## V2500-D5 SERIES PROPULSION SYSTEM NON-MODIFICATION SERVICE BULLETIN

# V2500-NAC-78-0232

NON-MODIFICATION SERVICE BULLETIN – NACELLE – THRUST REVERSER – BLOCKER DOOR LINK  
ASSEMBLY – INSPECTION OF CHAMFER

Figure 2

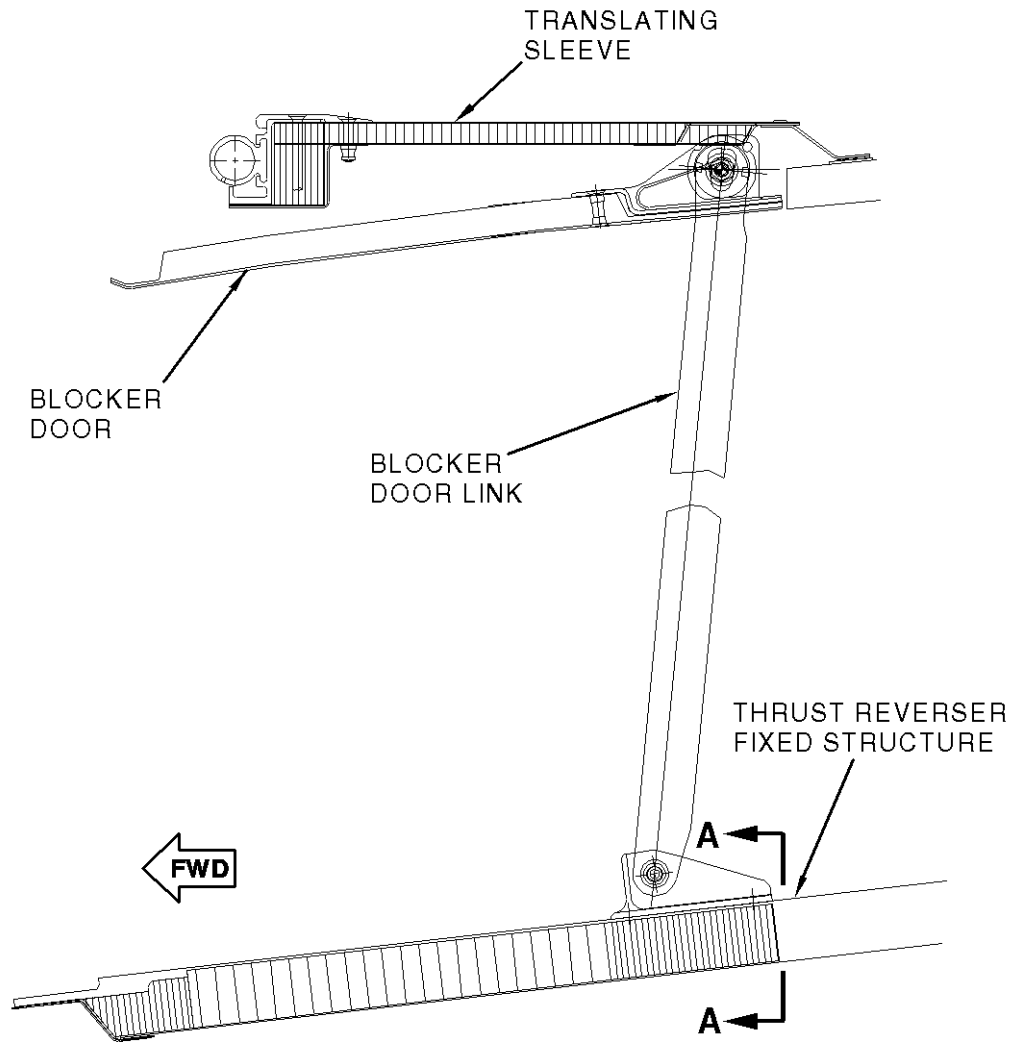
- C. For links removed in section 3.B., measure as accurately as possible, the outside diameter of the chamfer (link end common to TR fixed structure). See Figures 1 and 2 for details.

Cross-section of link end with bearing, pre-swaged condition.  
Measure indicated dimension to outer diameter of chamfer.

- (1) If the measured chamfer diameter falls within the provided tolerance, then no further action is required for that link.
- (2) If the measured chamfer diameter falls outside the tolerance range, rework the chamfer by removing the bearing per CMM Task 78-30-00-300-038, beginning with Subtask 78-30-00-350-084.
